Allens Creek Nuclear Generating Station Unit 1

Amendment 54 to the

Amendment 54 consists of additional PSAR information updating the PSAR to make it consistent with Revision 2 of the Allens Creek Containment Structures Design Report.

HOUSTON LIGHTING & POWER COMPANY
ALLENS CREEK NUCLEAR GENERATING STATION - UNIT NO. 1
PRELIMINARY SAFETY ANALYSIS REPORT
AMENDMENT NO. 54
INSTRUCTION SHEET

FIGURE 3.8-1

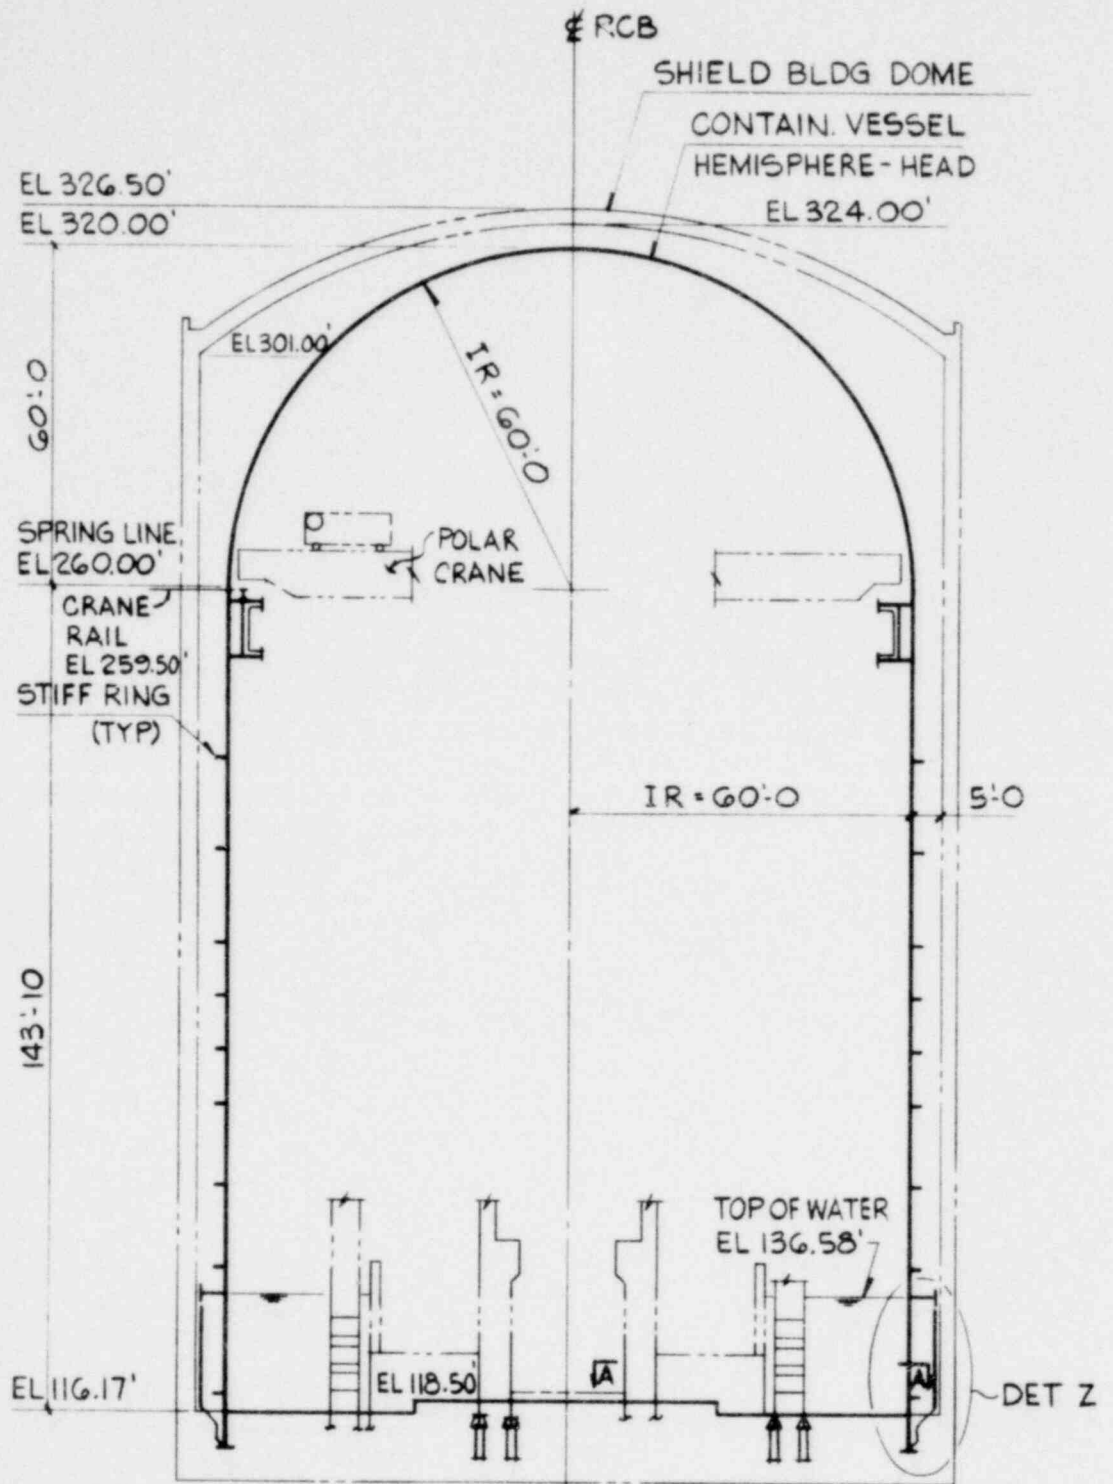
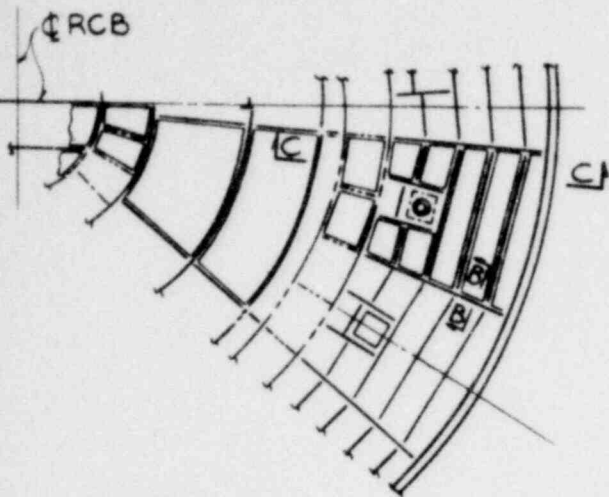
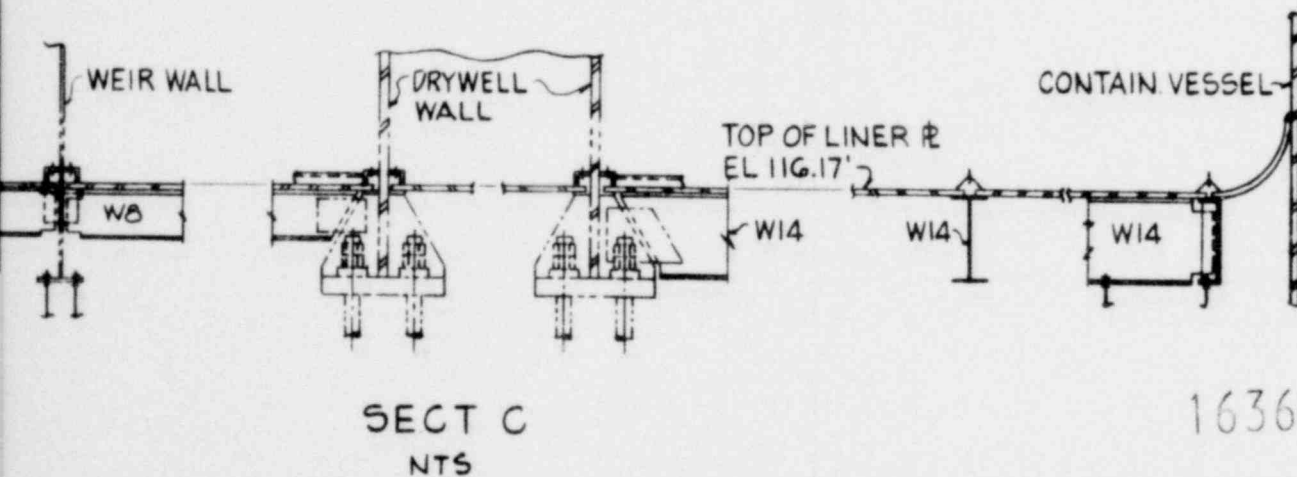
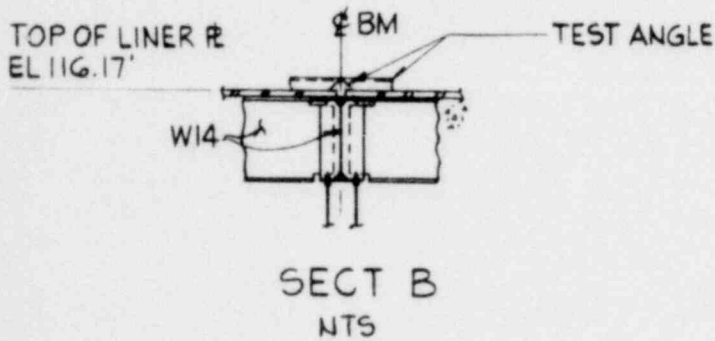
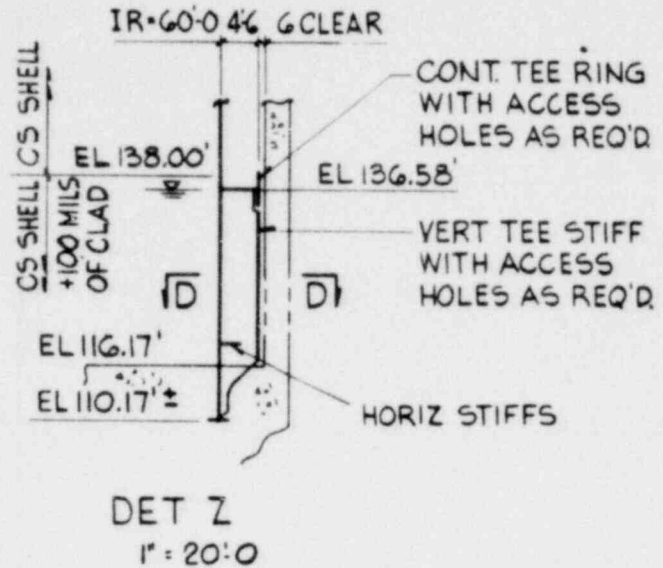
Features of the Containment vessel are shown in Figures 3.8-1 and 3.8-2.

The free standing steel Containment Vessel is a cylindrical pressure vessel with a hemispherical dome and a leaktight steel bottom. The bottom seal plate is welded both to an embedded grid in the mat and to the Containment vessel walls providing a leaktight bottom. The vessel internal diameter is 120 feet, and the total height is approximately 204 feet. The cylindrical portion of the vessel is adequately anchored to the building mat, but above this vessel is free standing with no physical links to the Shield Building of internal structures. An annular space is provided between the Containment and the Shield Building. 54

FIGURE 3.8-3

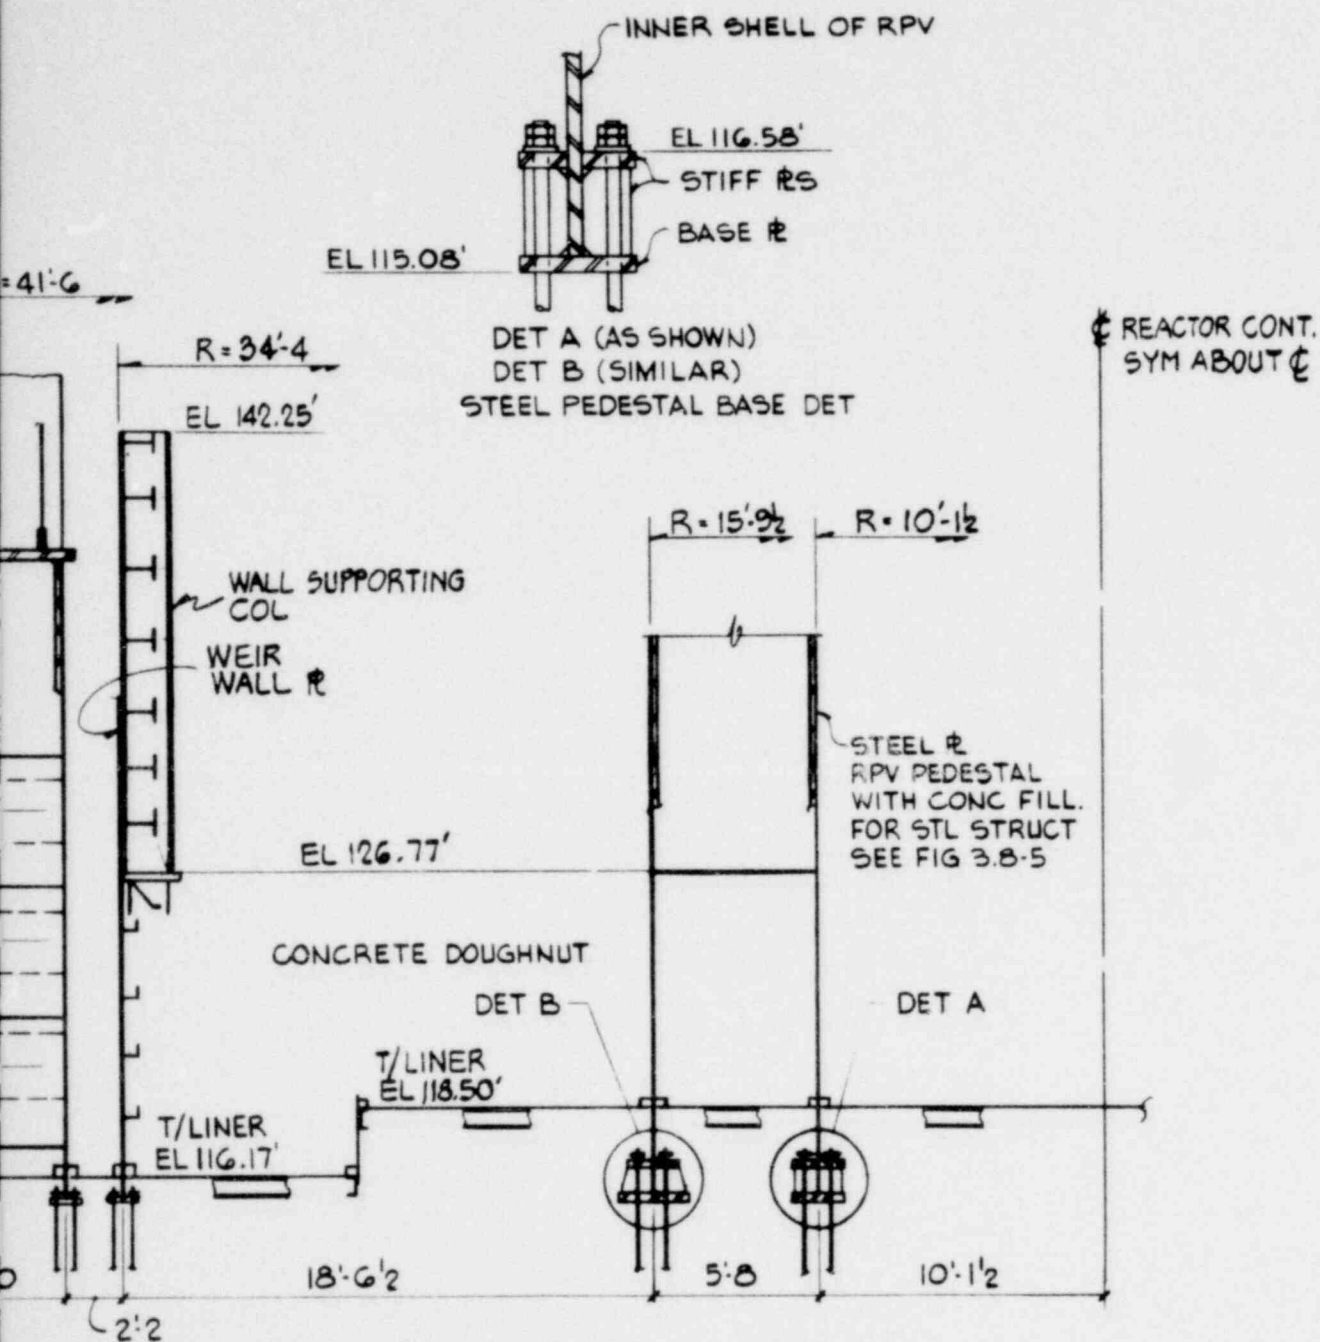
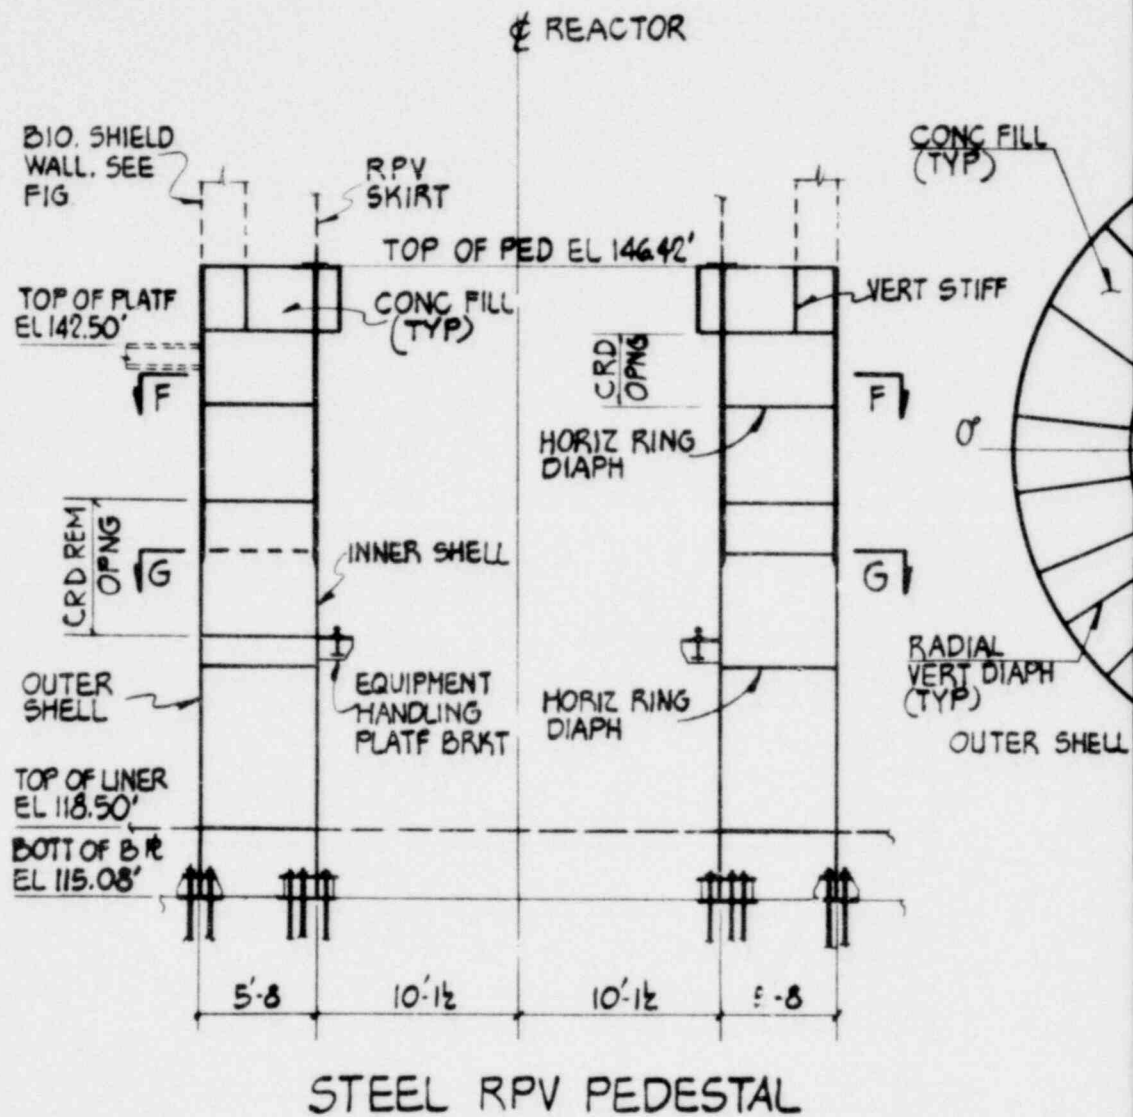
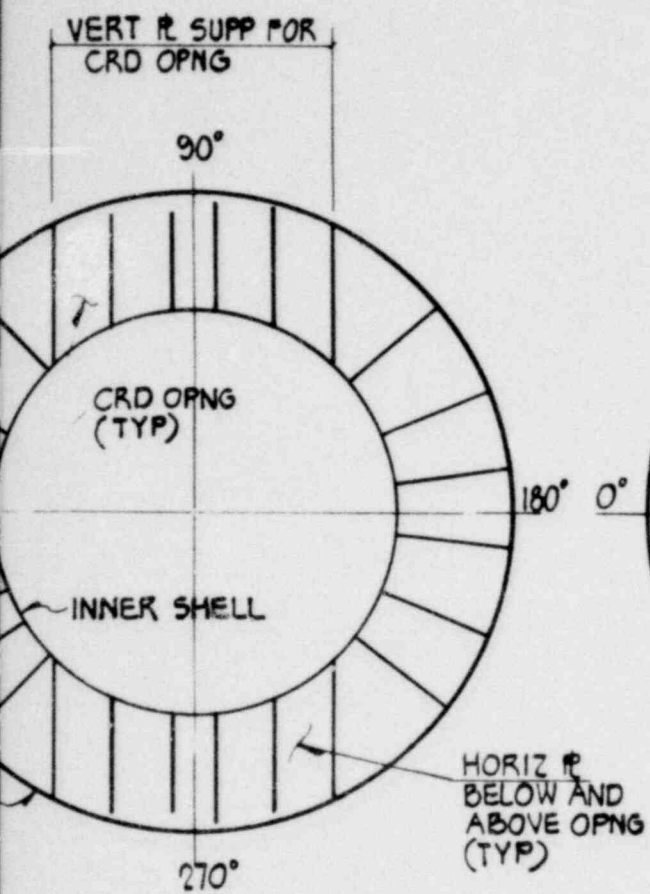
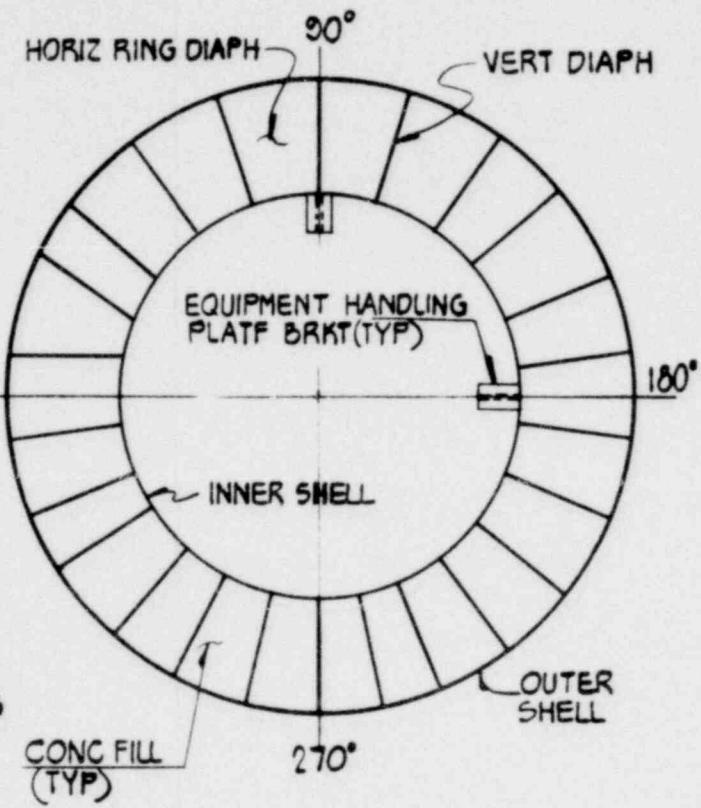
The lower drywell scheme will consist of two concentric cylinders fabricated of steel plate with longitudinal and vertical stiffeners provided as required by the design. These cylinders will be embedded into the mat, with embedments designed to withstand and transmit all loading effects. The vent openings will be fabricated of steel plate and will form part of the cylinders. The annular space between the cylinders will be filled with concrete in the region above the pool level for shielding purpose. Nominal reinforcement may be provided in the concrete fill, if composite action of steel and concrete is required. A continuous circular ring plate or girder will be provided at the top of the steel portion of the drywell, which will be welded to both concentric cylinders. The cadwelds for the reinforcing of the concrete portion above will be welded on this ring. The bottom liner of the Containment will be seal welded to the inner and outer faces of both cylinders. The outline of the drywell lower portion and the anchorage details are shown on Figure 3.8-3.
